■ MULTIPLEX COMMUNICATION SYSTEM

1. Major Difference

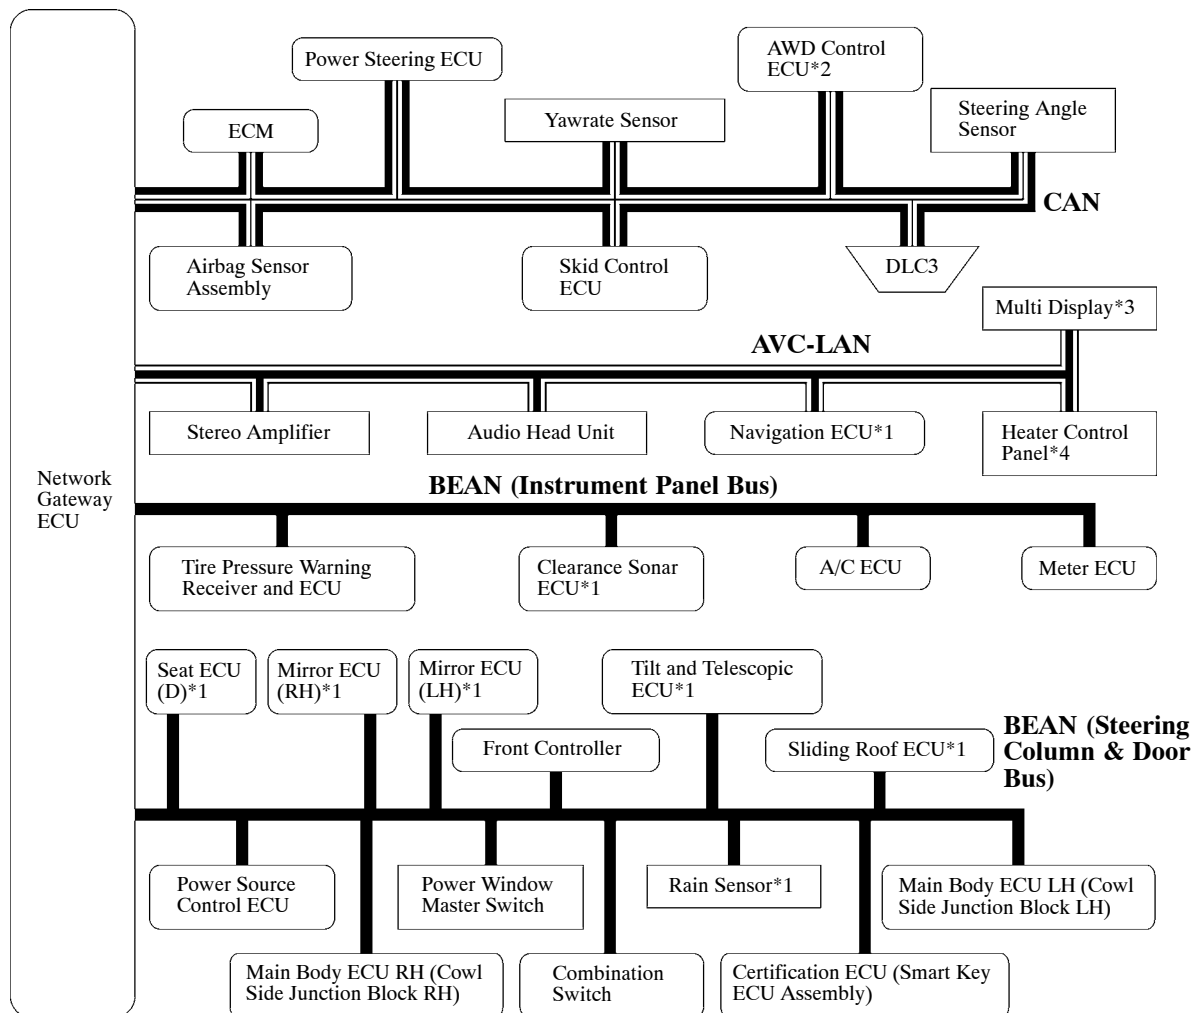
In accordance with change in the memory system and the discontinuance of the pre-collision system and the intelligent Adaptive Front-lighting System (AFS), the seat ECU (front passenger), distance control ECU and AFS ECU have been discontinued.
